SUBJECT

Grant of Land to Mr. D Puttiah, of Mysore, at Holenarsipur

Sanctions the sale of Land beyond C-D shown in the revised Plan

Sub Grant of certain lands in Holenarasipur town to one Mr D Puttiah

ROAD
17
MUNICIPAL OFFICE
PUTTIAH'S- CHOULTRY
PORTION TO BE GIVEN TO THE CHOULTRY
AREA 606½ SQ.
119
OF COMPOUND AS APPROVED BY THE MINISTER
AL SELF GOVERNMENT AND PUBLIC HEALTH
MATERNITY HOSPITAL
GROUNDS

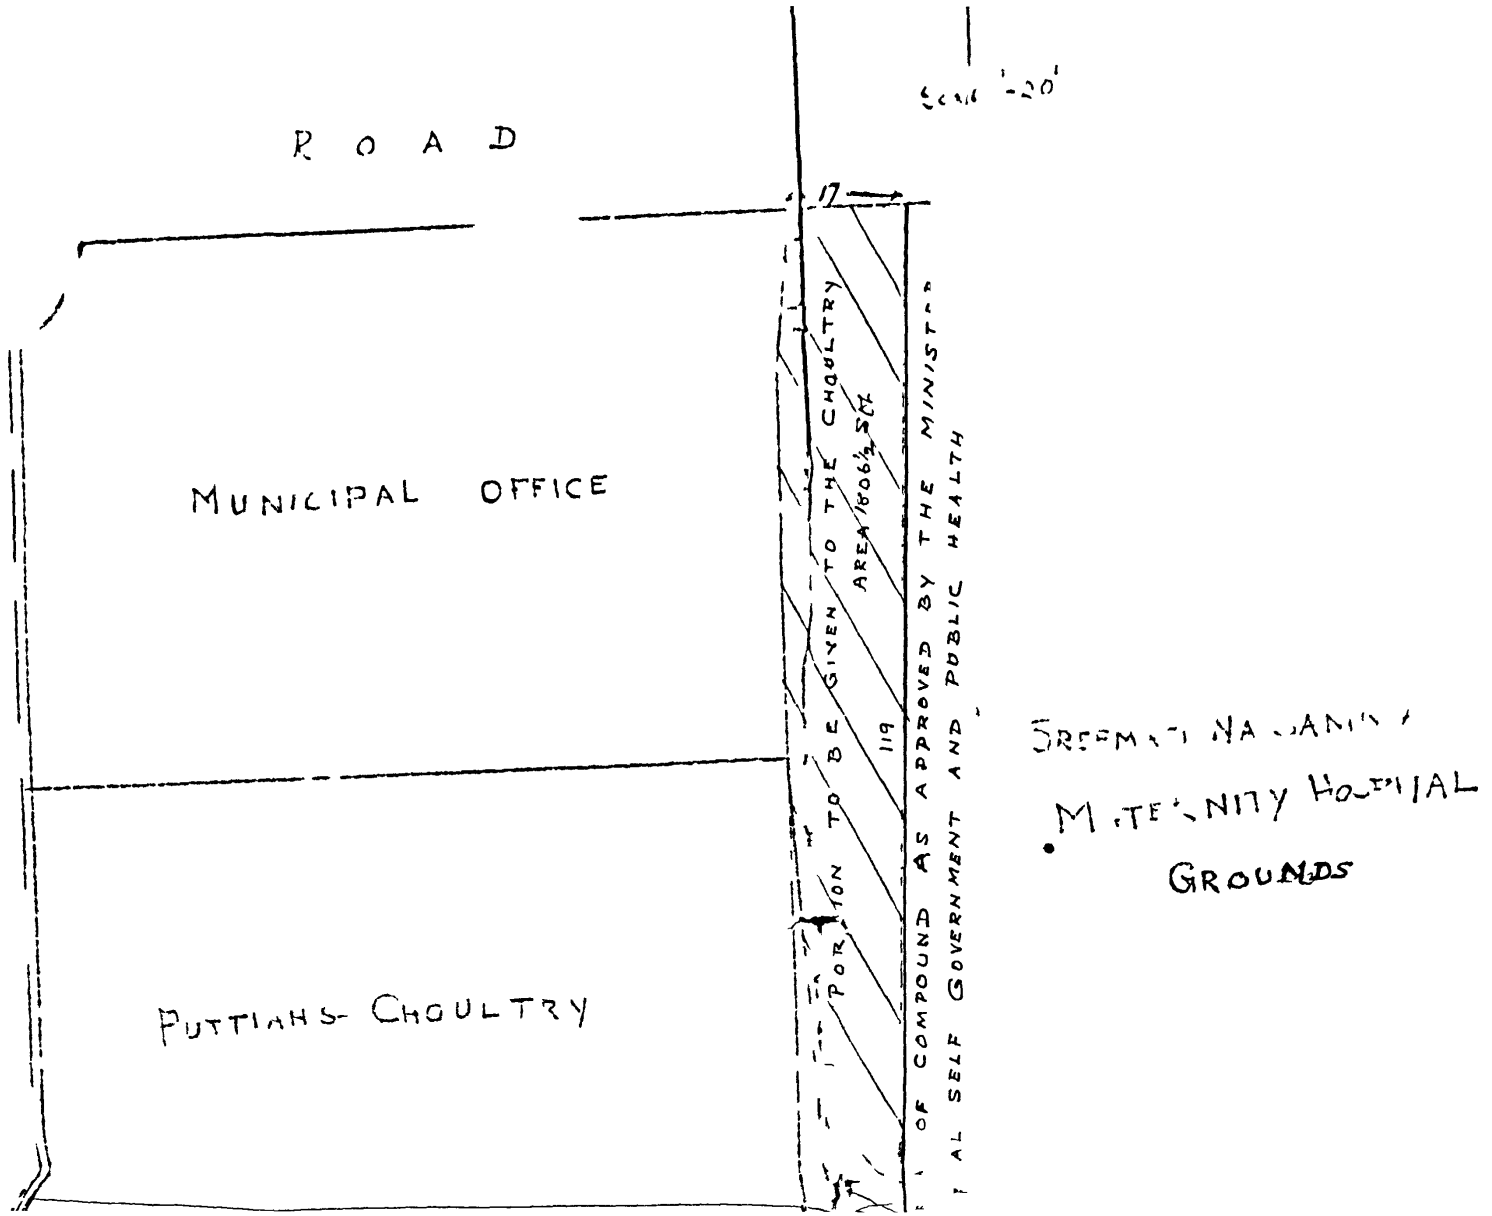
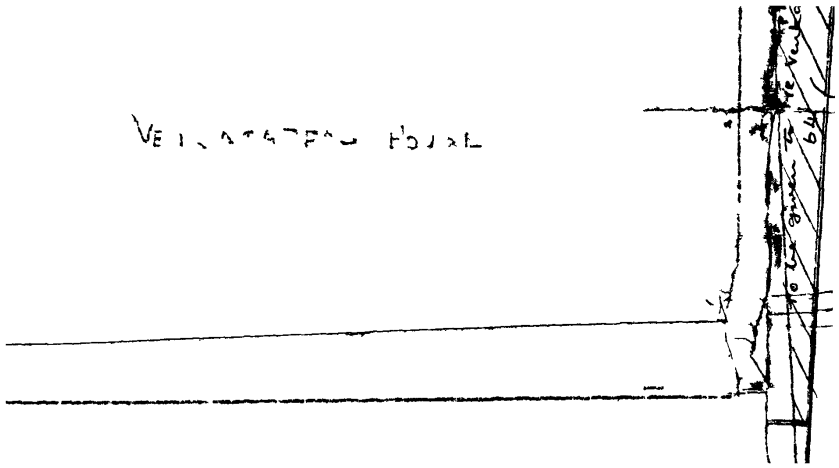
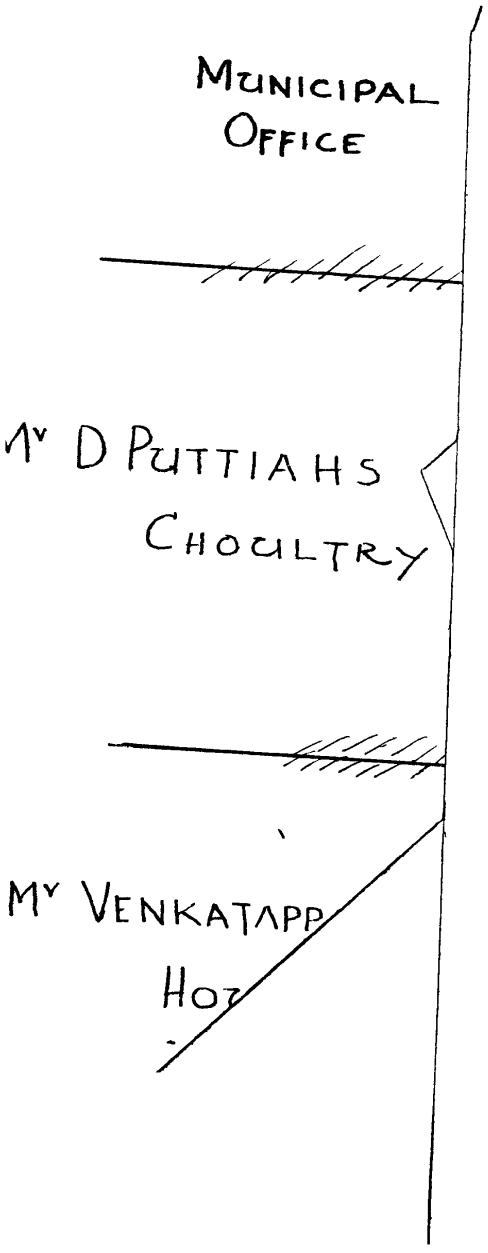
2 The bit of land 10' wide adjoining the choultry, which has been granted to Mr D Puttiah in Law Secretary's No L 2398/ML 120-42-45 dated 29-8-42 is shown in the plan The land has not yet been ceded to the applicant and no latrines or kitchen are built yet

3 The extent of land now prayed for by the party is 25' wide This is also shown on the plan

4 The position of the compound wall which will have to be constructed when the land as proposed by the Minister for Local Self Government and Public Health, is given away, is also shown as desired

5 The length of the compound wall to be constructed is 245' and the cost of execution will be about Rs 490/- at Rs 2/- per R Ft Of this length, 64' will have to be constructed by Mr Venkatappa who is next to Mr D Puttiah, at a cost of Rs 128/- He will have to agree to this condition also The remaining portion has to be constructed by Mr Puttiah at his cost as agreed by him

6 The area of land to be given to Mr Puttiah is 1375 S Ft or 153 S Yds and to Mr Venkatappa 434 S Ft or 48 S Yds at Re 1/- per S Yd which is the rate paid for acquiring the properties previously The total charges will be Rs 201/- only

1 The present space between the septic ward and choultry is 60 feet and if 25 feet were to be given from it only 35 feet will be left and since they propose building latrines and kitchen in the land if granted, the insanitary condition arising from those will tell on the health of the patients in the septic ward The people who come to the choultry are mostly halli people (villagers) who hardly know anything about flush system and are bound to make a mess of the place even if they were to be taught how to use the flush

2 The septic ward patients require a quiet surrounding and if the choultry is to be extended so close to the ward there is bound to be disturbance

3 The present septic ward is very small accommodating 2 beds At times, we have to put 4 patients with two on the floor close to one another for want of space and hence the septic ward may have to be extended at least in the future Even granting of 10 feet of land to the choultry will prevent us from building a spacious septic ward

The compound wall after giving the 25 feet will not be in a straight line but may be easily straightened

With reference to letter No L 7064/M1 120-42-247 dated the 15th January 1944, I have the honour to state that I inspected the locality and am in full agreement that the lines B C.D , marked in red in the accompanying revised plan will serve the purpose, as pointed out by the Local Self Government Minister When this new compound wall is built there will be a margin of 52 feet from the Septic Ward which is in occasional use

With Refce to the Correspondence ending with your letter No 19701 Dt 26.2.42 forwarding an Inspection Report in connection with the above subject, I am directed to convey the approval of Govt to your recommendation in the matter to grant to Mr D. Puttiah the land marked A B C D in the revised plan sent by you for the construction of the compound wall to the Chemistry and also a latrine. The party may be asked to put up the full-length of the Compound wall at his own Cost as per the design to be prepared by the Dept's authority. The latrine must be constructed by the party as per the plan to be approved by the Director of P H in Bangalore, Blore
